**S16 Planning Application for
Proposed Composite Redevelopment with Residential, Commercial and Trade Mart,
Social Welfare Facilities and School uses and Minor Relaxation of Building Height Restriction
at New Kowloon Inland Lot No. 6032, 1 Trademart Drive, Kowloon Bay, Kowloon**

(S16 Planning Application No. A/K22/37)

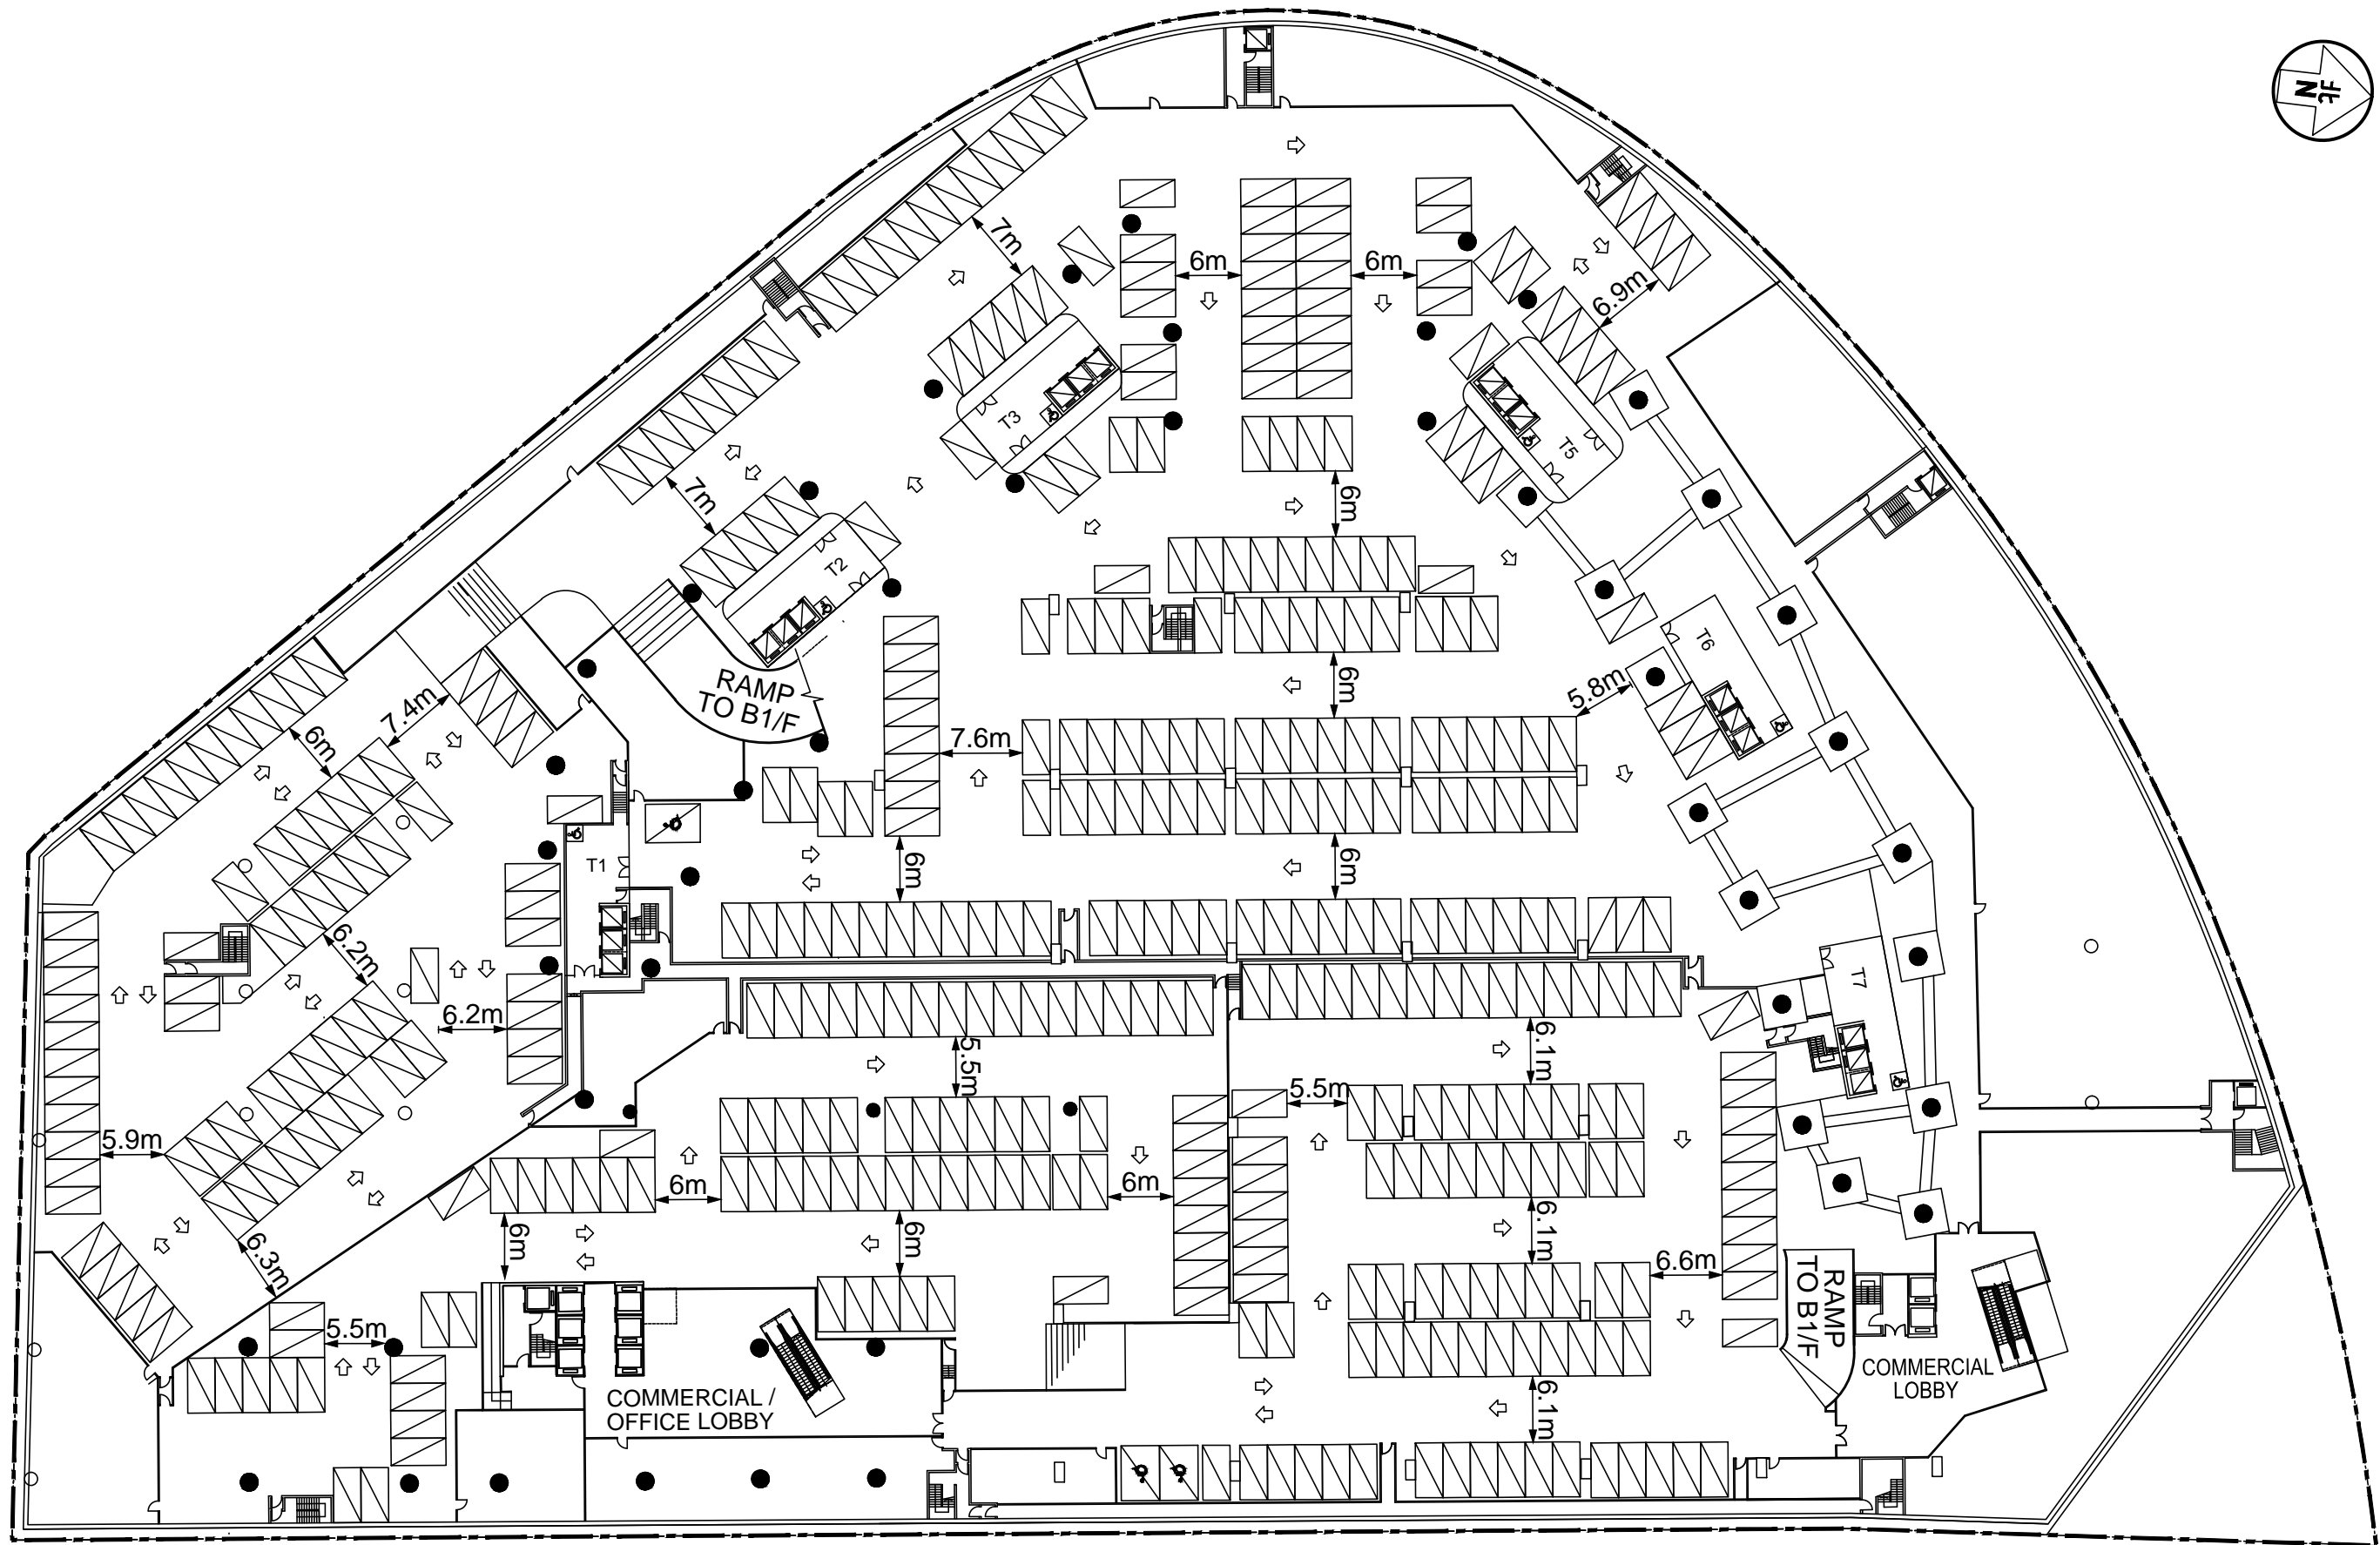
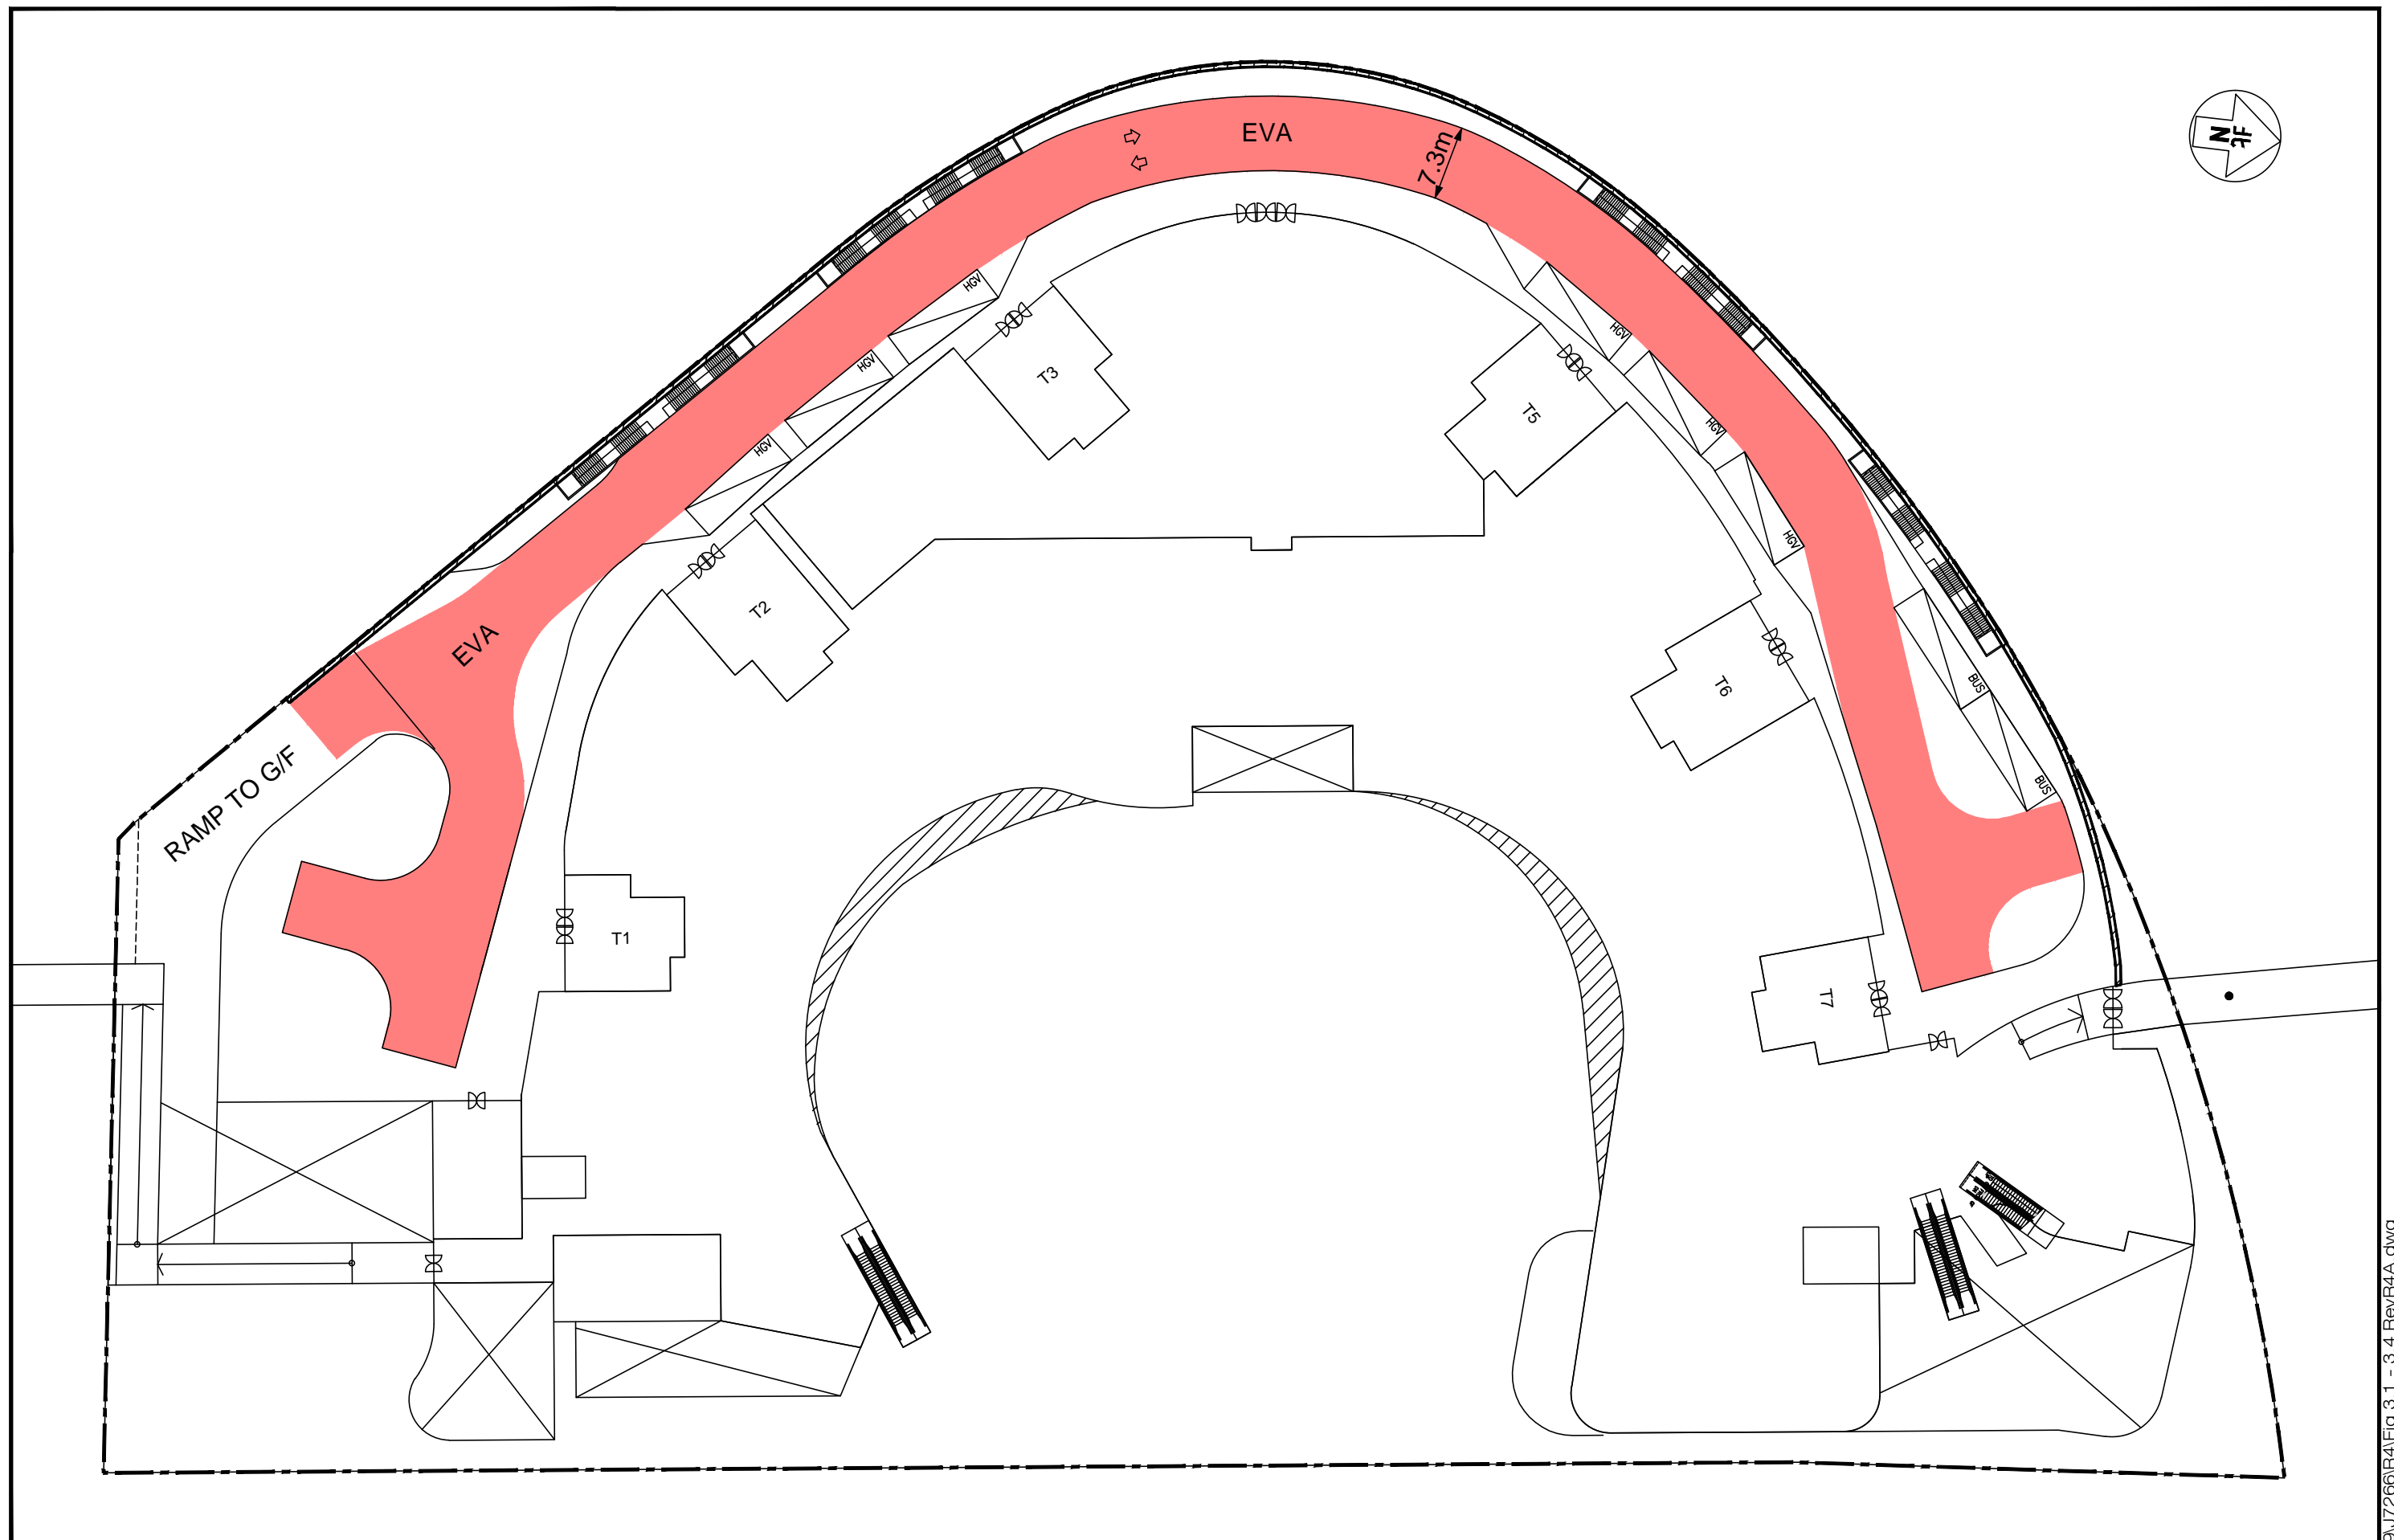
1.18	<p>Figure 3.2 and 3.3 Please refer to Annex C for the markup comments on the car park arrangement. Please confirm if the width of the driveway and aisle width of the parking spaces fulfil with the relevant BD' s requirements, such as BD's PNAP APP-111.</p>	<p>Please refer to the following amendments in response to the mark-up comments:</p> <ul style="list-style-type: none"> • Traffic directions are indicated in Figures 3.2 and 3.3; • Additional swept path analysis drawings have been prepared; and

Items	Comments	Responses
		<ul style="list-style-type: none"> The width of driveways and parking aisles has been indicated and the width satisfies the PNAP-APP-111 requirements. <p>After the s16 planning application has been approved, the Applicant will carry out detailed design of the internal transport layout in accordance to PNAP APP-111.</p>
